From: [Don Cole](#)
To: david.atkinson@sjimech.com; [Anjali Grant](#); [Gareth Reece](#)
Cc: [Jeff Thomas](#); [Ruji Ding](#)
Subject: RE: Summary of Sub 3 review for 2506-131
Date: Monday, February 23, 2026 12:09:03 PM
Attachments: [image001.png](#)

Subject: Re: Summary of Sub 3 review for 2506-131

Detail 1/IR-103 in the building permit set for 2506-131 shows the irrigation system being supplied between the RPBA and building connection:

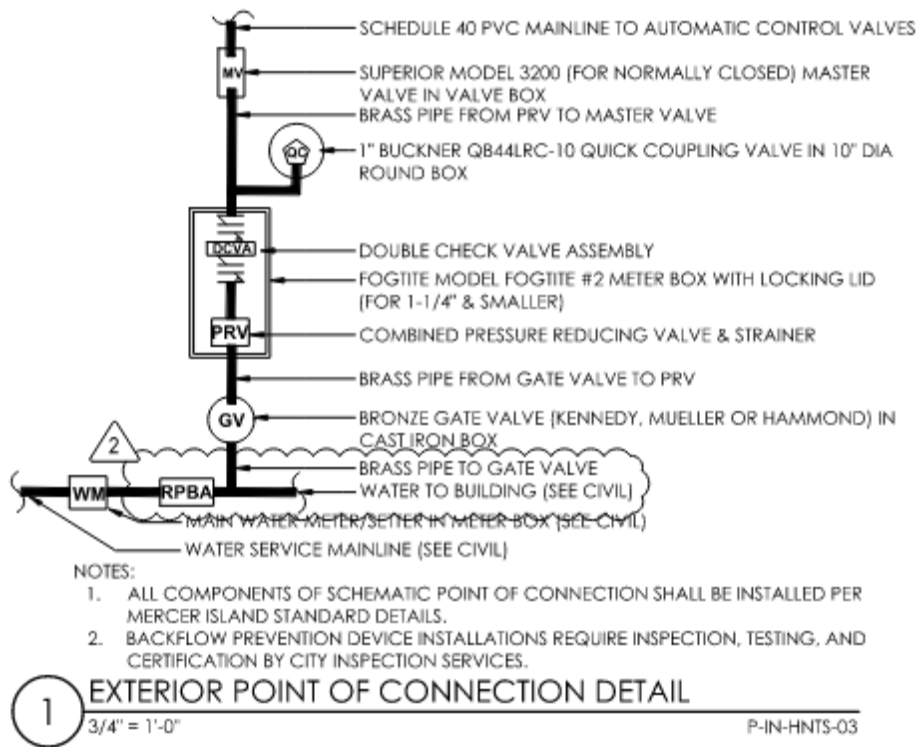
I don't see irrigation included in the WSFU matrix on P0.01 or branched on the diagram where domestic enters the building on P2.B1.2. Is this irrigation included in the plumbing calculations for meter sizing?

Regarding the plumbing review of the subject permit, your conclusion regarding the meter sizing with respect to the zoned irrigation system is acceptable.

Unless we need to address this differently, with point #2 regarding off hours the irrigation has no impact to water meter size.

The peak water usage (largest zone) of the irrigation system is 17.77 GMP as designed. The irrigation is assumed to be run one zone at a time, and is typically run during off-peak hours (typically early a.m. or after-hours).

The irrigation is not included in the WSFU matrix on the plumbing drawings.

Anjali – we need the landscape architect to help weigh in on peak water usage from the irrigation system. I see the valve schedule on IR101 but I don't know if the valves operate concurrently or not. Can you help track this down?
